SERVICE BULLETIN

SB1480

VEHICLE MODEL : CX45, CX35, TX40, TX45, TD925US, TDX25US

SUBJECT : To change rigid seat belt buckles of aisle side

Figure 1: Seat belt buckle types

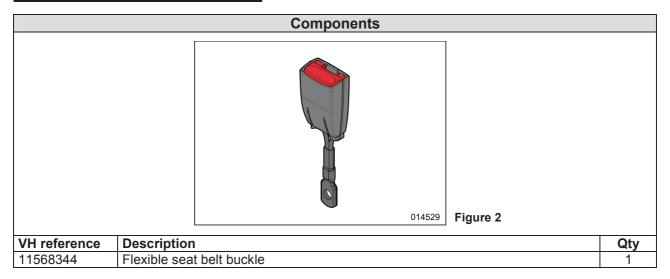
Subject vehicles have passenger seats equipped with seat belt buckles of which the outer casing may fail. These casings are held in place by one plastic notch only. When subjected to great pressure (e.g. by standing on the buckle or tampering with the buckle), these casings may fail and consequently slide down, thereby uncovering the buckle mechanism. These buckles, as and when the covers have slid down, may give passengers the impression that the buckle mechanism is defective and as such inhibit passengers from buckling up. Van Hool has determined that the seat belt buckles at the aisle side are prone to this phenomenon due to the rigid fixation of these buckles.

To address this issue, Van Hool is conducting a Safety Recall to change the rigid seat belt buckles of the aisle side passenger seats by flexible buckles.

Figure 6

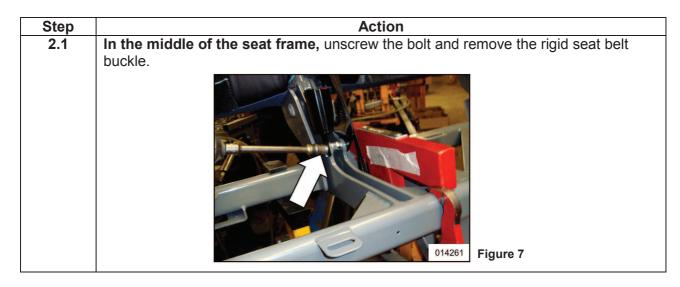
1.4 NOTE: The seat belt buckle release button should be visible for the passenger when he/she has fastened the belt.

Install the flexible seat belt buckle as follows:

- a. Install flexible seat belt buckle 11568344 (3) by using screw 7/16" x 1" 20 UNF (1), washer (2), spring washer (5), and nut (4).
- b. Put the flexible seat belt buckle in the proper direction and tighten the bolt to 22 ft.lbf (30 Nm).
